LANEWAY TO LAKE TUGGERANONG CONSULTATION REPORT

TRANSPORT CANBERRA AND
CITY SERVICES
PREPARED BY PURDON PLANNING

JANUARY 2019

Figure 1 Concept Design

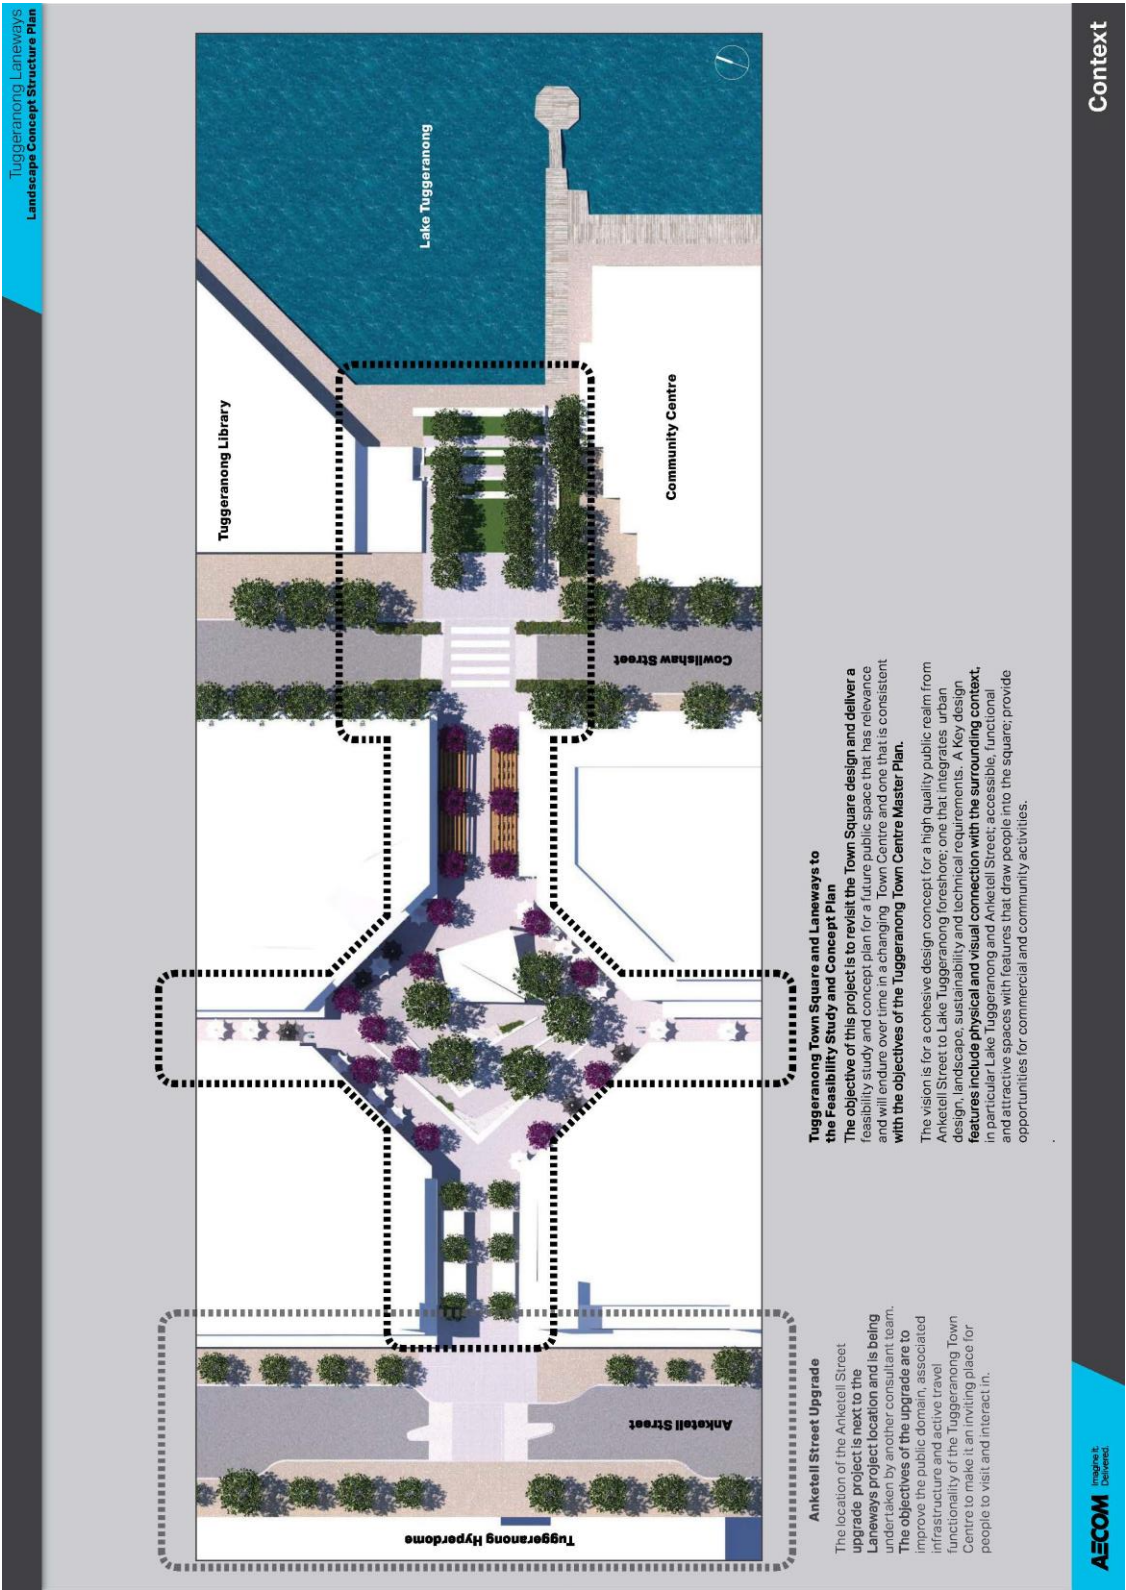
Element	Comment
WATER	<ul style="list-style-type: none"> Water harvesting from the Lake should be explored to reduce reliance on potable water and the cost of irrigation. Water from the Lake should also be explored if a water feature is proposed. Lake water can be treated on site to reduce risk to public health. Potable water will still be needed for drinking fountains. Another option could be to harvest stormwater for trees and other plantings, however this is often unreliable, and water can only be collected from public spaces.
TREES/ GRASS	<ul style="list-style-type: none"> Mature trees should be planted to provide shade as early as possible. No objection to removing existing trees as they are in poor health. Urban Treescapes should be consulted when deciding tree species to be planted. Soil type and preparation is important and critical for longevity of trees. 14-day public notice needs to be given prior to removal of existing trees. Services and underground infrastructure needs to be considered in relation to tree plantings to ensure compliance with clearance distances. Trees need to be clear of pedestrian crossings to maintain sight lines. Grass does not thrive around the base of trees and is not recommended to plant trees in lawn areas. Design grassed areas to for ride-one lawn mower width and maximum gradient for mowing.

LIGHTING	<ul style="list-style-type: none"> Lighting design needs to be cohesive. Light poles selected should come with the option to retrofit 5G small cell infrastructure. Majority of light poles are not compatible with additional data/cellular infrastructure. 5G infrastructure has an impact on visual amenity as control box, antenna, fibre all required on the pole. Roads ACT has the location of all proposed 5G cell poles, so they should be consulted.

AMENITY	<ul style="list-style-type: none"> • Unless there is a safety or design requirement, bollards should be minimised rather than emphasised; other design measures are preferred to replace bollards wherever this is possible. • Any solid rails on stairs will be used by skateboarders – consider appropriate treatments when designing. • Consideration should be given to skateboard users and areas that TCCS does/does not want them to use. • Ensure that pavement treatments specified are slip resistant, particularly in icy conditions; Kingston Foreshore given as an example of surface where there is risk of slipping and injury. • Power bollards of necessary voltage to be installed to support events and other uses of the space. • Drinking water should be provided at the Lake frontage for walkers; noted that a drinking fountain is already provided near the Anketell Street entry to the Square.
ACTIVE TRAVEL	<ul style="list-style-type: none"> • Slow cycling should be encouraged through the square. • Bike storage and locks should be provided. • Use materials to delineate slow speed cycling areas and implement friction points.

BINS	<ul style="list-style-type: none"> • No new bins to be included, replacement bins only. • Prefer bins to be double shrouded to include general waste and recycling; currently there is no provision for collecting recyclables. • Consideration to be given to waste vehicle access. Trucks will stop on Anketell Street and access the bins by foot.
ART	<ul style="list-style-type: none"> • Tuggeranong Arts may wish to be involved in the design of artwork on the paving if this is proposed.

Theme	Comment	Response
Connectivity/access	Better connectivity to the Hyperdome (South.Point) is preferred	The existing concept plan improves connectivity to the Hyperdome (South.Point) through improved gradients. It is important that access to South.Point is not the sole objective of this proposal as South.Point is an enclosed shopping centre which does not promote pedestrian activity externally. The objective of this proposal is to invigorate the Town Square and that means pedestrians should be encouraged to stay within the Square, not just use it as a thoroughfare to South.Point.
	The garden beds on either side of the crosswalk on Cowlshaw Street potentially obstruct the	The end design will be compliant with road safety regulations.

Theme	Comment	Response
	<p>line of site for pedestrians and drivers. They should be removed to improve pedestrian safety.</p> <p>Drivers need clear sight from at least 20 metres ahead to allow ample stopping time</p> <p>Car parks have the same speeds as adjacent streets, 50 in this case, which is excessive. Car parks should be signed at 10 km/h.</p> <p>The speed limit on Cowlshaw Street is far too high (50 km/h), it should be reduced to 10km/h and made into a shared zone. This is worth considering for Anketell Street too. Changing the signs is not enough to slow speeds. Drivers regularly exceed 40 or 50 down this stretch and road design should be changed to force lower speeds.</p>	<p>As above.</p> <p>This is not within the scope of this project. This comment will be passed on to Roads ACT for consideration.</p> <p>A raised crossing is proposed across Cowlshaw Street, however reconfiguration of the entire Street is currently not within this project scope. The comment on reducing the speed limit will be passed on to Roads ACT for consideration.</p>

<p>Paths should not be overly interrupted by furniture and other obstacles.</p> <p>Bicycle traffic should not be permitted down the upgraded laneway. Cyclists should be required to either walk or take alternate routes. This requires providing high quality separated bikes paths down parallel roads like Pitman Street, Reed Street and through the adjacent carparks to divert them.</p>	<p>Street furniture location will be considered in the context of pedestrian and cycle accessibility and will be positioned to ensure effective circulation.</p> <p>This comment is not representative of the views of the majority of other community groups, lessees and the broader community. The majority of people consulted supported cyclists using the Square but wanted slow speed cycling only. A dedicated cycleway through the square or laneways is not proposed.</p>
Anketell Street Upgrades	Do not support immovable street clutter like the benches on Anketell Street in all areas. Useful to have open spaces in highly trafficked areas which could be used for performances.	Performance space is proposed in the Square and towards the frontage to Lake Tuggeranong. Some seating may be spread-out in the Square to reduce clutter at the frontage to Anketell Street.

Figure 3 YourSay comments

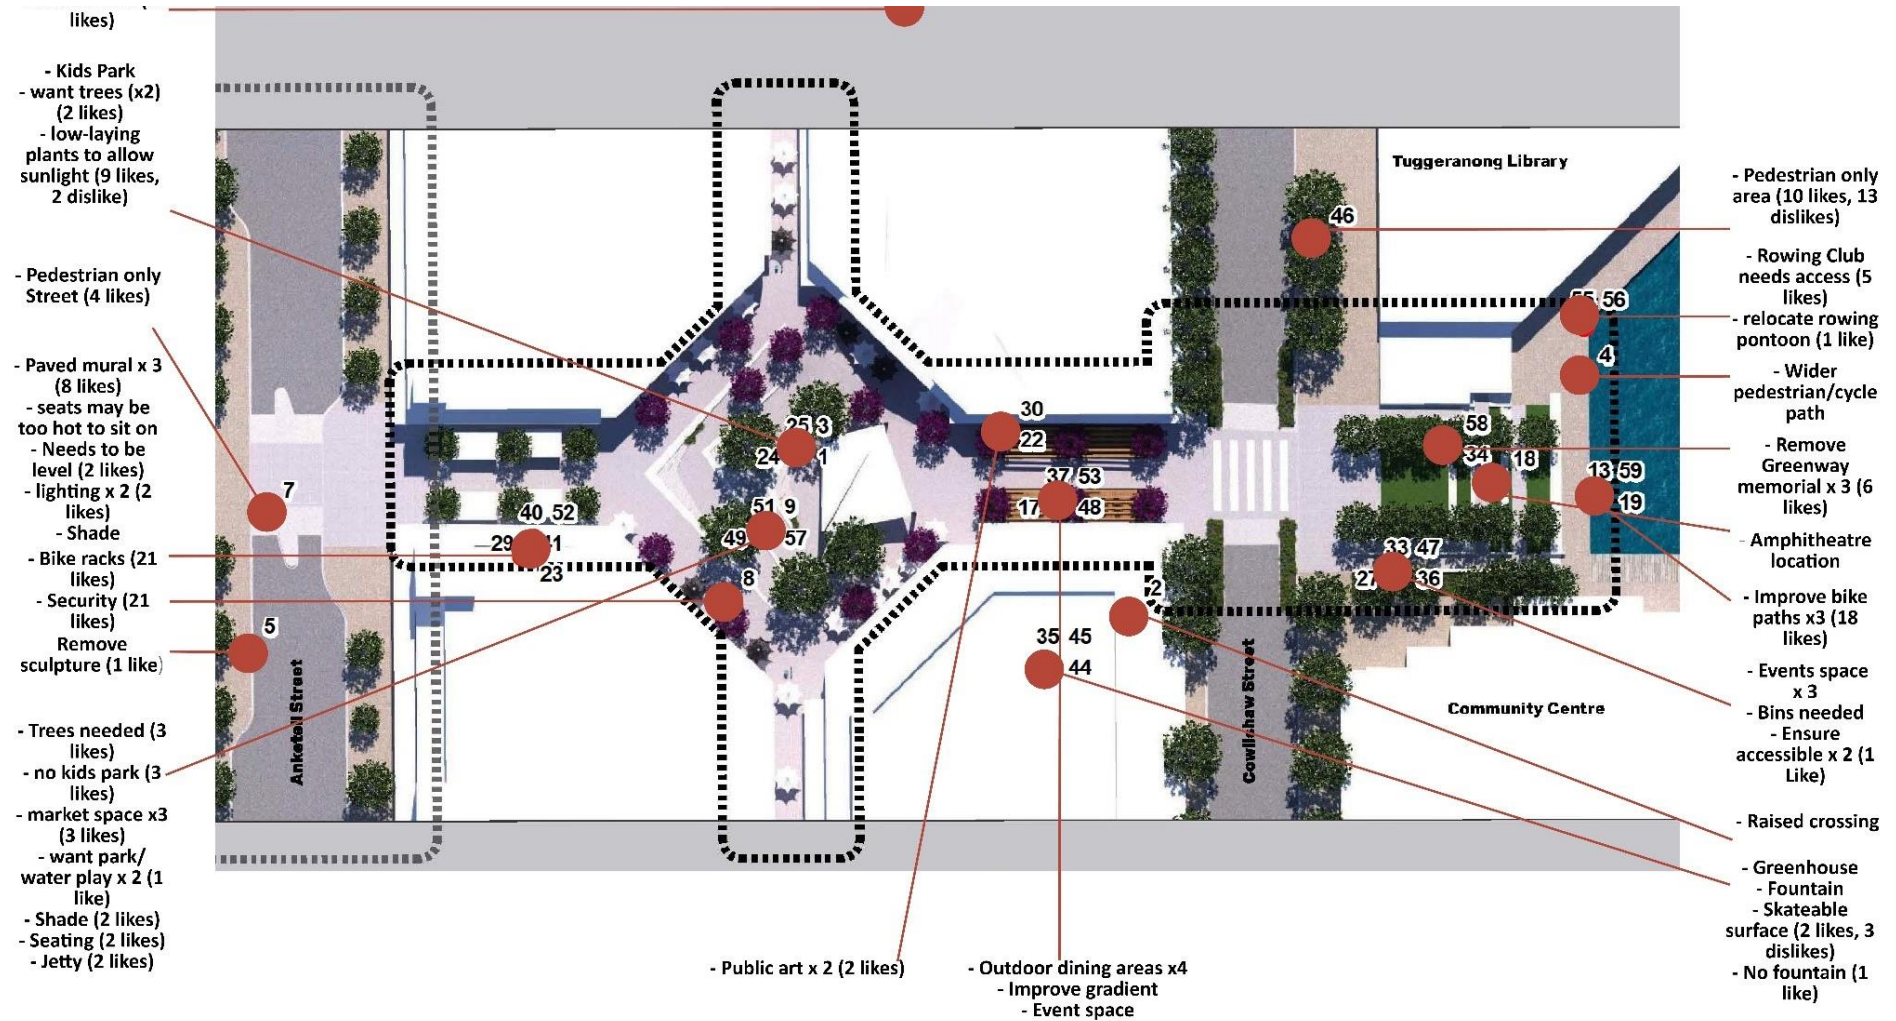
Number (refer Figure 3)	Comment	Up Votes	Down Votes
1	Whilst trees in this courtyard are lovely it would be great to make this a small fenced park. It would be fabulous if you could have cafes at the bottom of these building looking out on to a fenced playarea. It would give people a reason to come and stay in the courtyard and is closely located to the shops and the library. There is a big gap in fenced playarea in Canberra particularly near shops.	0	0
2	I don't know whether it needs to be raised but I can say that crossing it with my 80 year old mother now and again during the day is always a bit nerve-wracking. Drivers are faster and a bit more inconsiderate than elsewhere. I never feel confident they will stop. But maybe with more activity around, drivers will be more aware of pedestrians.	0	0
3	Yes, and please not eucalypts. I love them but not in this sort of space. Something deciduous that gives seasonal change eg Manchurian pears.... And whatever is planted there, it needs to be well watered. Our climate is almost arid and we need spaces to retreat from the harsh heat and brown landscapes in heart of summer.	0	0

4	Wider pathways and a cycling lane to ensure safety for both cyclists and pedestrians who are accessing the lake near the lane way. It currently can be a little tricky to navigate around the boardwalk area when there are a number of walkers/runners and cyclists about.	3	0
5	The metal 'sculpture' erected over the footpath here is about as inspiring as an old bike rack - could we get rid of it please? If the view of the lake is so important then draw the eye to that rather than interrupting it with boring tubular metal. One of the reasons I moved to Canberra decades ago is its celebration of the natural environment so let's keep doing that.	1	0
6	Cafes and dinning areas. This would be a better area to have them instead of having them along Anketell Street right next to passing traffic.	2	0
7	Please make this section a pedestrian only area. Cafes and restaurants face this street and vehicle traffic makes the experience unenjoyable. This area could then be used for street markets and festivals or similar.	4	0

8	I'd like to see this area opened up to a range of casual dining options, coffee shops, outdoor eating. Improved lighting, music, artworks, seating, bike racks & some trees or shade sails. This area has great potential to bring people outside, but we need a reason & feeling of safety to walk through here.	21	0
9	Would love to see a water play area, seating, family friendly area away from the street, where you can enjoy coffee, drinks and casual dining, beer garden type atmosphere with music.	0	0
10	Shade, shade shade!	0	0

Number (refer Figure 3)	Comment	Up Votes	Down Votes
11	Completely agree. An effort has been made to improve the outdoor seating at the cafes on Anketell, but the experience can be ruined by the amount and noise of the traffic.	5	0
12	Closing Anketell much preferred.	0	0
13	Agreed, this area needs to be widened significantly and the sharp right angle bends eliminated to make it easier to use what is a very popular area for walking, riding, or for just lingering and enjoying the lake.	1	0
14	I would simply like to suggest that for this lovely area, you do NOT adopt the same approach (ugly, uninviting yellow and orange metal seats) as used for the new "park" in Trenerry Square, Weston. I pass Trenerry Square almost every day, and no matter what time or weather, I have yet to see anyone sitting there. It's definitely a prize contender for some "Hostile Urban Design" award.	0	0
15	Some good ideas here but you need to give people a reason to go down to the lake and move away from the mall. Cafes and retail are needed all the way through here to make it inviting for shoppers. Not just your regular franchise stuff - something local, different and a bit quirky. Maybe some start up businesses - make it affordable for small and emerging businesses.	0	0

16	The lane way should be more than just line-of-sight to the lake, it needs to be level all the way through eg. not having to walk around the current raised platform. This will allow older citizens to enjoy the changes. Shaded seating on the sides and by the lake would be great, to ensure the sight lines are not cluttered like they are now. Lighting would need to be improved to make it less scary walking down the lane. I like the other comments of aboriginal artwork through the paving.	2	0
17	I like the idea of alfresco coffee/dining if there are nice establishments. How are they going to be attracted to open up? The diagrams don't show the existing gradient - there are a couple of sets of steps down towards the lake as I recall. How is that going to be managed? It isn't flat like shown.	0	0

Number (refer Figure 3)	Comment	Up Votes	Down Votes
18	Ideal for a well-designed, community amphitheatre for 500 - 600 Tuggeranong Valley residents and visitors to enjoy a variety of live music performances, Shakespeare by the Lakes performances (we would love to use it!), dance festivals, open-air movies at the best outdoor performance space in the ACT. The stage complete with a backdrop could be on the water and the green-terrace park moved back across the street or the amphitheatre could be grassed like Qbyan's QEII park.	8	0
19	Yes, better bike paths for the lake will be very beneficial because as it is right now it feels like a hazard to go through.	1	0
20	The grassed area out the back of the library could also be rejuvenated and utilised in further developments to match what is being done in the laneway. Increased seating would make for a very nice area for lake walkers.	7	0
21	The benches that run along the side of the library are really good and should be kept or upgraded.	3	0

22	Or even allow local school groups and artists to paint on the columns in front of the lawyer's office.	0	0
23	Totally agree! Good lighting is a must.	0	0
24	We would still like trees, as long as they are deciduous. People want light in the winter, but shade in the summer.	2	0
25	I think the biggest area for improvement within this square is that it's a very dark space due to the height of the surrounding buildings and the trees. Having plants installed which are not too tall would open the space up, let some light in, and make it an overall more inviting space to travel through.	9	2
26	Or other cultural events like they do at Lake Burley Griffin.	0	0
27	In conjunction with these three areas, the park area near the pool, and the grass areas on the other side of the lake, special community events could be held like a mini skyfire or what they do out at Googong. With multiple vantage points around the lake and the new housing near the dog park, the whole lake is in line of site and fireworks could be set off!	0	0

28	Lighting in this area and the other two spaces would be very important, especially if people are going to dine there at night, it would make the space feel a lot safer and be able to use the grass areas even at night. Soft, warm lighting would look best but all corners need to be lit up.	2	0
29	The local college, primary and high schools could have a design competition! Much like the mosaics outside Woolworths. Would also create a community feel.	2	0

Number (refer Figure 3)	Comment	Up Votes	Down Votes
30	If there are blank walls in this space or the one in front of the lake, some trendy or meaningful murals from local artists could create a hot spot for talking photos and might discourage graffiti, maybe. It would also really add some feeling of culture or community.	10	0
31	The seating on this boardwalk is good and should be kept. Maybe a rejuvenation of the safety railing to match the new aesthetic.	7	0
32	This is a great little boardwalk but maybe it could be made more wheelchair accessible. Also I'm not too sure what it's intended purpose is because at the moment it's pretty run down with a pointless flagpole.	9	0
33	When combined with the main courtyard this will be a huge area and a fantastic space for markets! The community centre, library or college could even run open days or their own fete like activities here.	0	0
34	This is a great idea! I don't know if it's the library's duty to maintain or someone else but make it a public space or get the library to open it up to users but it is a beautiful courtyard with great views and should be used! I know if it was open, college students would most definitely go there in lines off.	0	0

35	The lake is already there, don't know if we need more water, plus that would mean more maintenance and cost to run.	1	0
36	Bins are a must! We don't want the area becoming a messy area because people litter. Maybe place bins on the edge of every row or two? The ramps down the side look suitable for wheelchair access and bikes. Keep the landscape and furniture simple will create a good flow between the shops and lake.	1	0
37	This would create a better link between the lake and Hyperdome. I think a lot of people, parents and dog owners walk around the lake and would certainly stop by for coffee at a cafe after their walk. Cafes and restaurants down this end would also expand the 'restaurant hub' that Anketell Street is. This also adds a dining option closer to the lake that isn't fast food. Walking there now there is plenty of room for seating on both sides while still having a large walkway in the middle!	2	0

38	Love the idea of rejuvenating this space as it builds the Tuggeranong area and makes the popular spaces more than just the Hyperdome. Hopefully this will bring more business to existing businesses (such as Decadent and Jindebah Coffee) in the square and will encourage more to move into the buildings that always seem to be empty. With CIT and Tuggeranong College nearby this could be a great area for students and teachers too.	0	0

Number (refer Figure 3)	Comment	Up Votes	Down Votes
39	Yes yes yes! Trees are a must for practical reasons and to make the area more appealing. Love the suggestions of markets in the space! Getting rid of the big planter boxes and the existing raised area will make the laneway flow better and be easier to walk through, at the moment it's a bit of a maze.	2	0
40	It is cold in the winter, but in the summer months when more people go out during the holidays, the wall might be in the full line of the sun and make it too hot to sit outside.	0	0
41	I totally agree to that! The area has so much potential to become an antipode to Gungahlin or even Braddon. Right on the lake, with a corridor to the shopping centre!	0	0
42	I am looking forward to getting rid of the above ground planter boxes with the current trees in them and bringing the whole thing to a more natural ground level. I can see that there will be challenges with that. Activities in the space will turn it into a place that attracts people.	1	0

43	I would like to see local artists and artisans using the empty shop spaces and selling their wares market style on the weekends. The open walkway should also be available for organisations to use for fundraising selling food, plants etc at different times through the year. Would also be great for live music and busking.	3	0
44	Also, a greenhouse for water birds or plants if it is possible.	0	0
45	I like to see a delicate fountain. If the fountain can also use for water curtain movies, that will be fantastic! No bricks please! Need smooth surface for rolling/skating through. One last thing, the lane near Mortimer Lewis Dr is too rough. I hope it will not cost too much to renew the surface.	2	3
46	We need to make this a proper pedestrian area - remove all unnecessary cars. Pave the area and make it easy to go from the lake and back to the shops/restaurants. Cars do not add to this area and let them use Athlon where the main road and parking is at.	10	13

47	Keep this free of clutter to enjoy the waterfront. Lots of seating and places just to enjoy the area. But we need nice restaurants next to the area - and that is not maccas or KFC. They are drive throughs - and is in opposition of what it looks like we are trying to achieve. Move them up the back to Athlon..... where the cars are!	2	0

Number (refer Figure 3)	Comment	Up Votes	Down Votes
48	Lets let the sun in so we can enjoy it!!! so we need to work with the seasons. Covert the offices to niche cafes - they need to be there to bring in the people. Offices kill the space during recreational times (like after work and weekends!) Retractable awnings might be nice to bring the Melbourne laneway type of experience to Canberra.	0	0
49	Agree - deciduous trees a must for cooling in summer and sun in winter. But not the playground - that should be bigger and more available at the park. I'm thinking markets each Saturday like paddington or others to support local artists etc. Be another with Bus Deport alternative. Food stalls. Fun. Buskers. Provide seed money for a year or two to get established and auction sites each 6 months.	3	0
50	A permanent jetty on this side would also fit in aesthetically with the timber jetty on the other side, behind the community centre.	0	0

51	Trees need to be deciduous to ensure winter sun. Shade sails, or preferably adjustable louvres, should be angled at 30degrees north for winter sun and summer shade. Over reliance on business to supply dining areas also means that people have to buy from those restaurants to sit. Public seating is essential. I suggested a jetty over the lake for events (markets, temporary food stalls etc) and that could easily extend all the way through to Anketell St and join up with the restaurants.	2	0
52	The name Tuggeranong is from Ngunnawal language for "cold place". A massive local, indigenous artwork through the whole walkway built in using coloured paving would be lovely and engaging for local community. Because of design and the buildings, the walkway gets a lot of shade during the cooler months, which means it is cold. Using the south side for seating / dining would be preferable. The walls are large & cold which deters stopping and eating. Soften north walls with evergreen climbers.	4	0

53	Consider space for market stalls or food / coffee carts. People need a reason to gather in an area. The north west side will be heavily shaded during most of the year because of the low sun. Opening up the southern side more to dining areas will hopefully get more sun access during winter making it more inviting to sit in warm winter sunshine.	2	0

54	People often walk out on the rowing pontoon just to get a better look or check out the waterbirds. Why not actually build a permanent jetty out over the water that has space standing and/or seated bar areas for eating and dedicated spaces for temporary food stalls / coffee carts, a weekend market etc (a bit like the former Kerb market in UK, before it grew)?	12	0
55	Perhaps the Rowing Club pontoon could be moved to a new area under the bridge on the opposite side of the lake (or somewhere else suitable).	1	0
56	While the area needs re-vitalising and the plans look great, Lake Tuggeranong Rowing Club (located on the waterfront beneath the Library) need access through this space to carry their Rowing boats for loading onto their trailer for transport to Regattas. This also requires a safe off-road area to load the trailer and equipment. That currently occurs on the pavement at the top of the stairs.	5	0

57	I'd like to see some kids playground equipment put in this area. It's quite close to the shops and restaurants and it would be really useful to have a public play area close by for kids. It could be incorporated into the design with the shade and seating.	1	0
58	Are you intending to remove the small courtyard attached to the Library (as it is never utilised and always looks dirty) and this would open up more community space between the Library and the Community centre.	6	0
59	Access for cyclists riding around the lake. No consideration into the width of the path or turning circle for a bicycle to move through this area safely and not impede any pedestrian walking through.	16	0
